Access Compliance Report Public Rights-of-Way (Curb Ramps)

Main Street: FOSTER_RD Cross Street: KITTRICK_DR Location: SE

ADA ID: RPAT211202085201 Ramp Type: Type 1 - Perpendicular Diagonal Initial Pass/Fail: Fail Overall Compliance: No Severity Score: 4

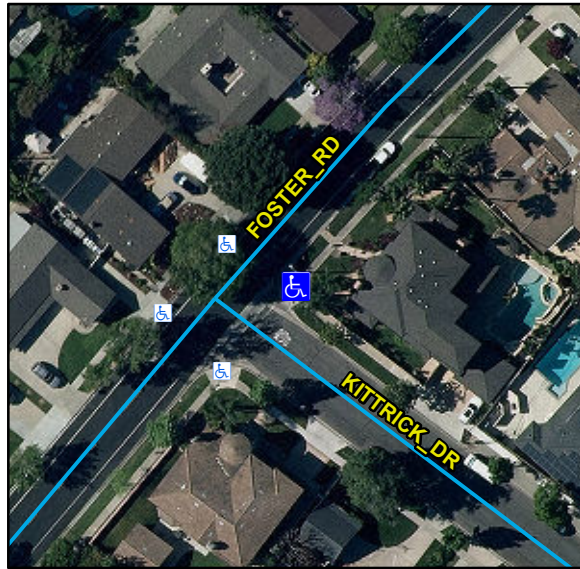
Compliance	Description	Data	Compliance	Description	Data
N/A	Ramp Length (in)	82	N/A	Flare Type LT	
No	Ramp Width (in)	39			N/A
Yes	Ramp Run Slope (%)	7.9	N/A	Flare Slope LT (%)	N/A
Yes	Ramp Cross Slope (%)	1.1	N/A	Flare Traversable LT	N/A
N/A	Landing Present	N/A	N/A	Flare Type RT	
N/A	Landing Length (in)	N/A			N/A
N/A	Landing Width (in)	N/A	N/A	Flare Slope RT (%)	N/A
N/A	Landing Run Slope (%)	N/A	N/A	Flare Traversable RT	N/A
N/A	Landing Cross Slope (%)	N/A	N/A	DWS Provided	N/A
N/A	Landing Movement Obstructed?	N/A	N/A	DWS Contrast	N/A
	Landing Movement Type	N/A	N/A	DWS Length (in)	N/A
N/A	Landing Shared	N/A	N/A	DWS Full Width	N/A
N/A	Clear Space	Yes	N/A	DWS Offset Left (in)	N/A
N/A	Clear Space To Crosswalk (in)	N/A	N/A	DWS Offset Right (in)	N/A
N/A	Marked Crosswalk 1	No	N/A	Marked Crosswalk 2	No
	Crossing 1 Direction	NW		Crossing 2 Direction	SE
	Marked Crosswalk 1 Width (in)	N/A		Marked Crosswalk 2 Width (in)	N/A

N/A	Ramp Inside Crosswalk 1	N/A	Yes	Ramp Inside Crosswalk 2	N/A
	Crossing 1 Slope (%)	6.2		Crossing 2 Slope (%)	3.3
	Crossing 1 Cross Slope (%)	0.1		Crossing 2 Cross Slope (%)	2.8
N/A	Gutter Ponding	N/A	N/A	Curb Slope	7.9
Yes	Gutter Lip Height (in)	0		Road Run Slope (%)	1
N/A	Gutter Run Slope (%)	N/A		Road Cross Slope (%)	2
N/A	Gutter Cross Slope (%)	N/A			
Yes	Overall Surface Condition: Acceptable		No	Perp Joint Present	No
	Cross Gutter Present?	Yes		Spandrel Present?	Yes
	Replace Cross Gutter?	No		Replace Spandrel?	No

Remove & Replace Curb Ramp With Two New Directional Ramps or Equivalent.
